PLANNING BOARD DECISION

Application Type: **SITE PLAN REVIEW**

Project: **Amesbury Elementary School**

Date: **February 08, 2021**

Planting | Revised Plant Material

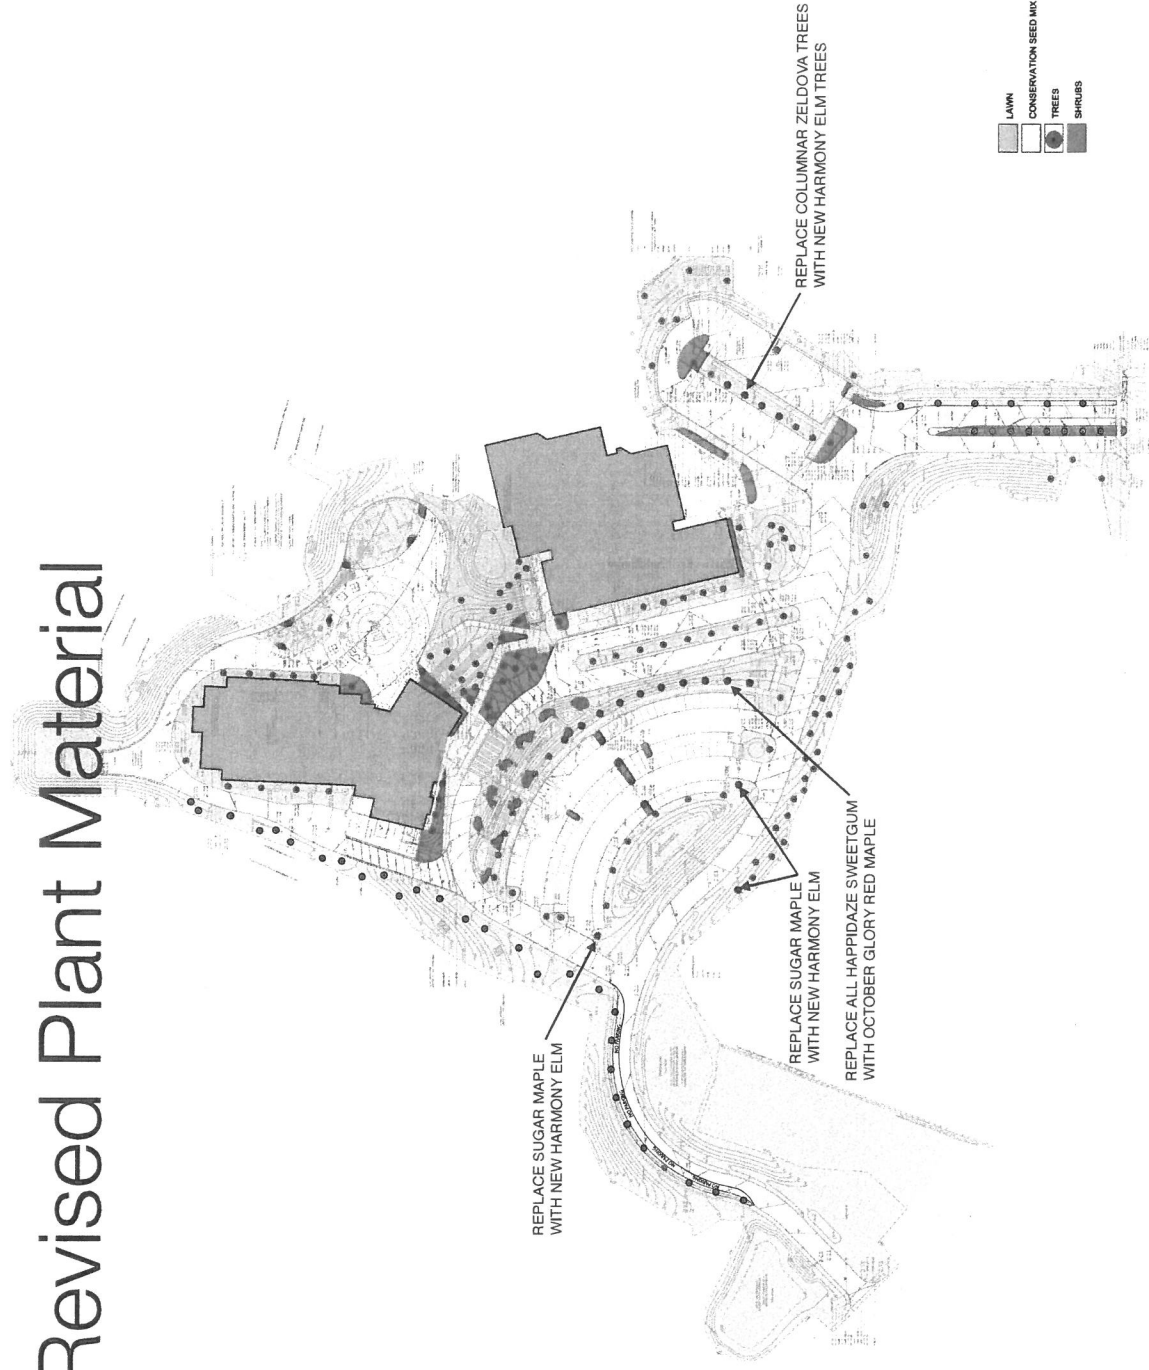
10. **Landscaping:** A landscaping plan was submitted along with the Site Plan. The Board discussed the need for additional trees along the Woodsom Farm to provide some vegetative buffer in between the natural landscape and built environment. In order to reduce the heat-sink effect, trees with large canopy were incorporated into the parking

areas. The Board also finds that the grass strips and trees in between the sidewalk and travel lanes provide additional physical safety zones for school kids and other pedestrians. The Board finds that once the landscape design changes (Exhibit #1 - #3) have been incorporated into the Final Plans, the purpose and intent of the landscape requirements would be satisfied.

Revised Plant Material as presented to the Board on 01/25/2021

Eastern Driveway | Revised Design

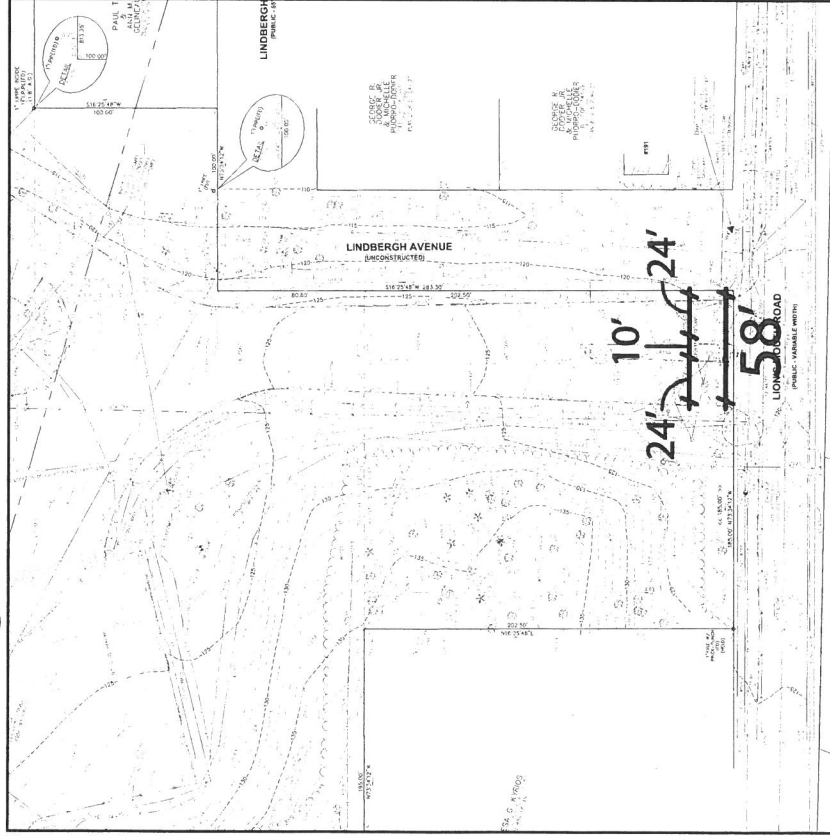
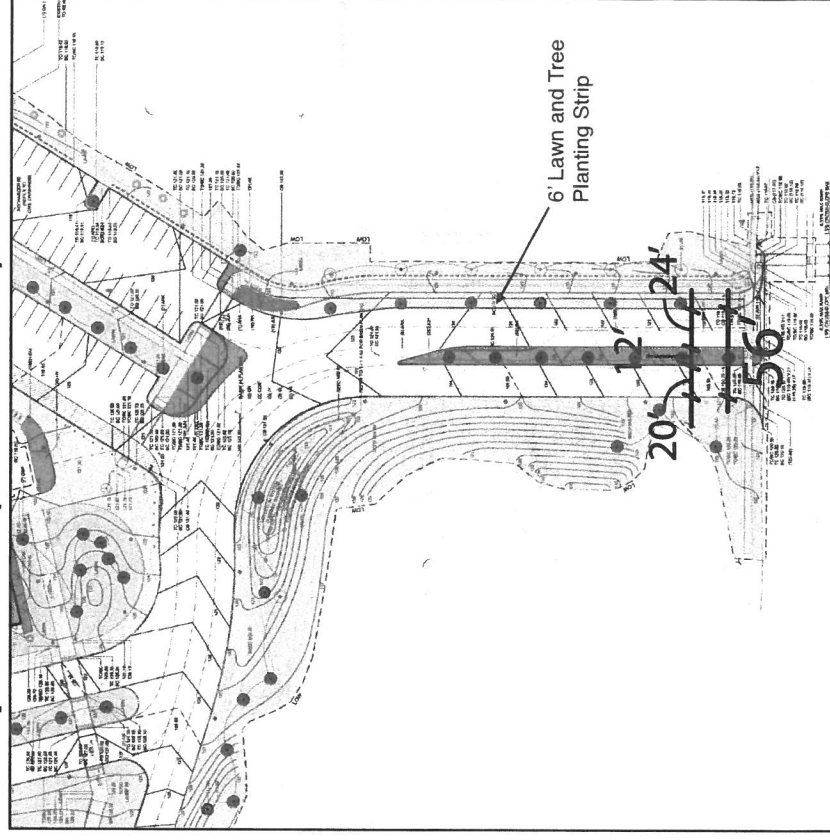
Section(s) of Zoning Bylaw	Requested Waiver	Decision of the Board
Section XI.C.10.n.1 – Requires pipe material be reinforced concrete and that a minimum of three (3) feet of earthen cover be provided over pipes.	To allow <ul style="list-style-type: none"> a) provision of less than three (3) feet of earthen cover over drainage piping as stipulated below b) the use of HDPE material for piping in lieu of the required reinforced concrete material for pipe segments provided with a minimum of 2.5 feet of cover. c) the use of Class V RCP material for piping provided with earthen cover ranging between 1.8 and 2.5 feet. 	Granted to the extent necessary provided all site and building improvements are carried out as per approved plans
Section XI.C.8.a.3 – Curb cut width	To make improvements to the existing 58 feet wide curb-cut and reduce it to 56 feet including a 12 feet landscaped median as shown on the revised driveway sketch	Granted to the extent necessary provided final site plans are updated to incorporate the driveway sketch as approved

Eastern Driveway – Revised Design, as presented to the Board on 01/25/2021

Highland Street & Friend Street Concept Plan #8 & #9
Complete Streets Prioritization Plan
Amesbury, Massachusetts

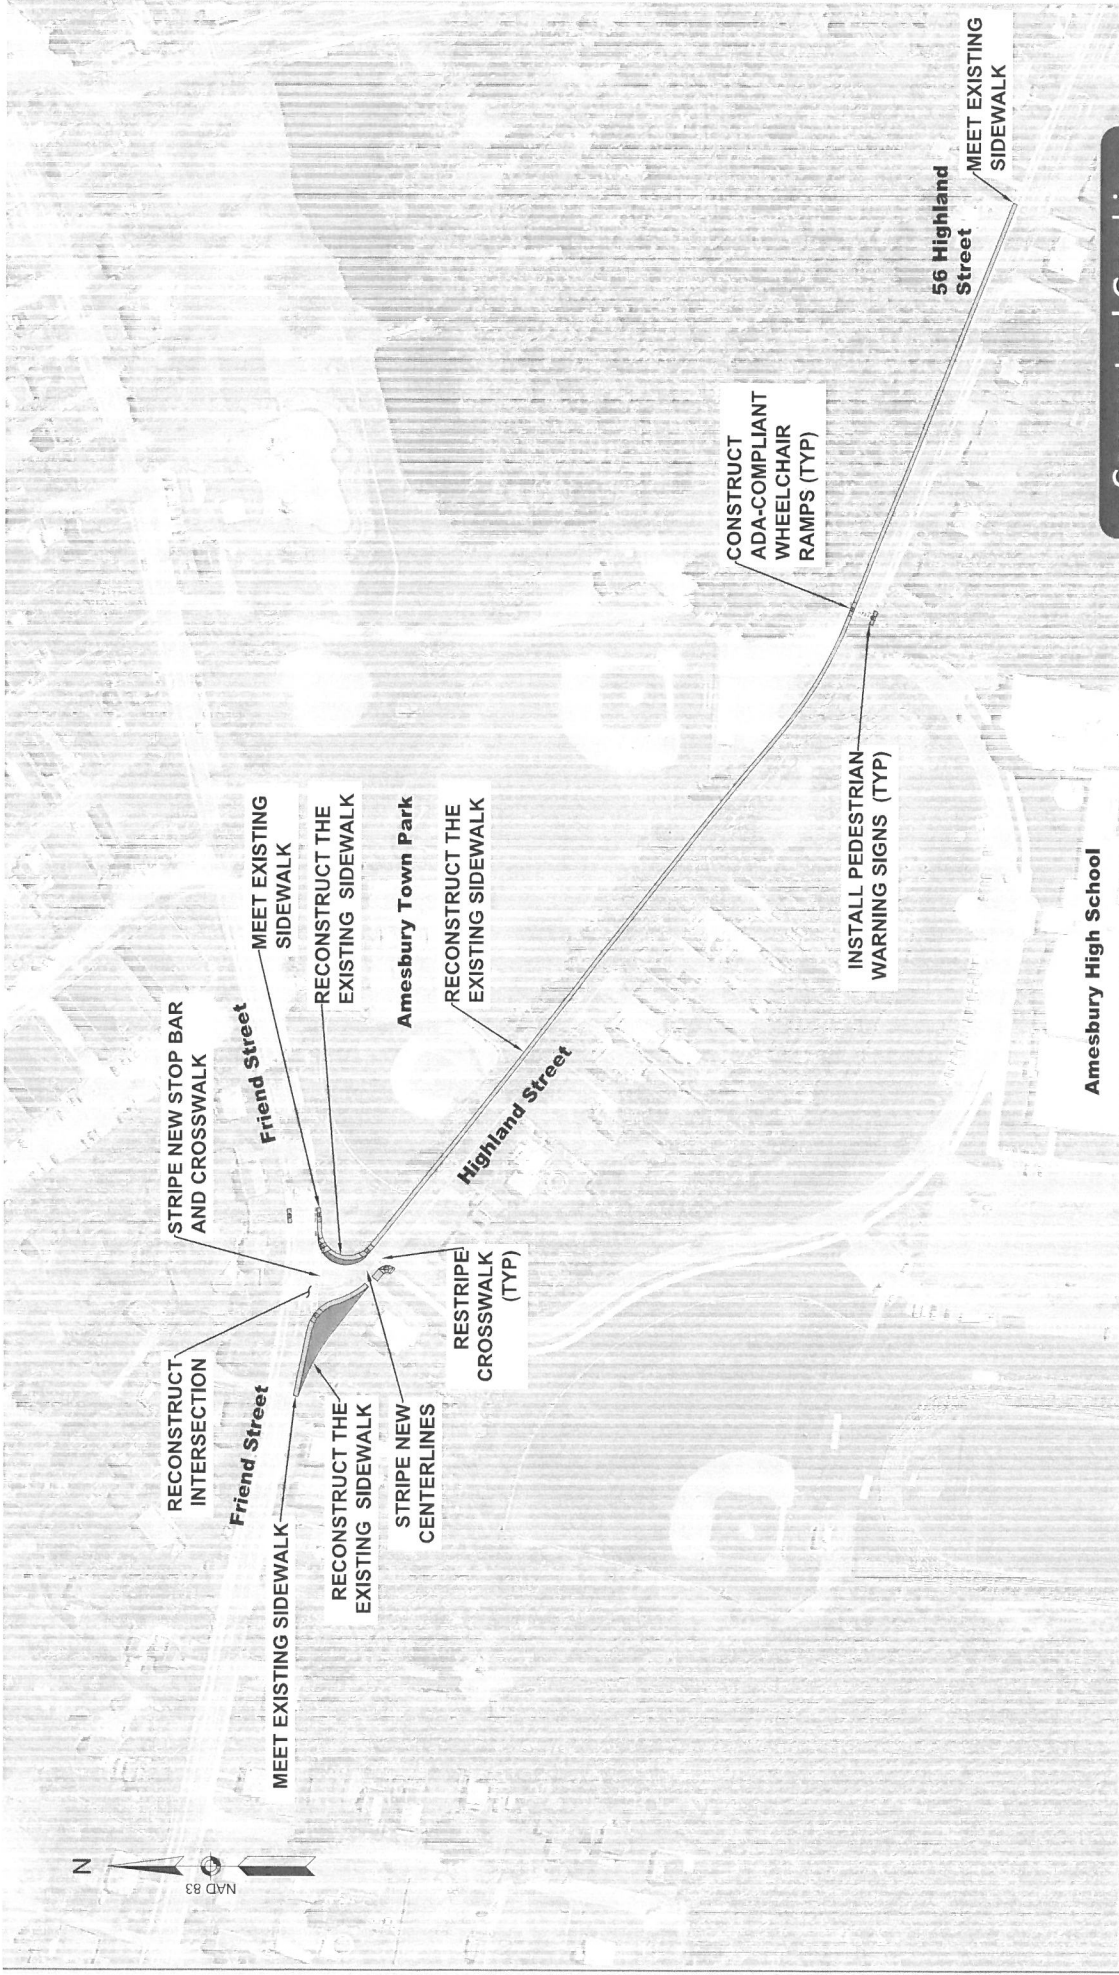
9. The Long Term Pollution Prevention Plan (LTPPP) shall be incorporated into the project construction documents;
10. **Traffic Studies and Improvements:** The recommendations from the Board's Traffic Peer Review by VHB dated 12/14/2020 are incorporated here by reference as conditions of approval. Further, the off-site improvements related to sidewalk and intersection

reconfiguration and reconstruction as shown on and included in information package submitted on Sep 29, 2020 (Exhibit #4) shall be required to be completed no later than 12 months from the issuance of the Certificate of Occupancy for the new AES building.
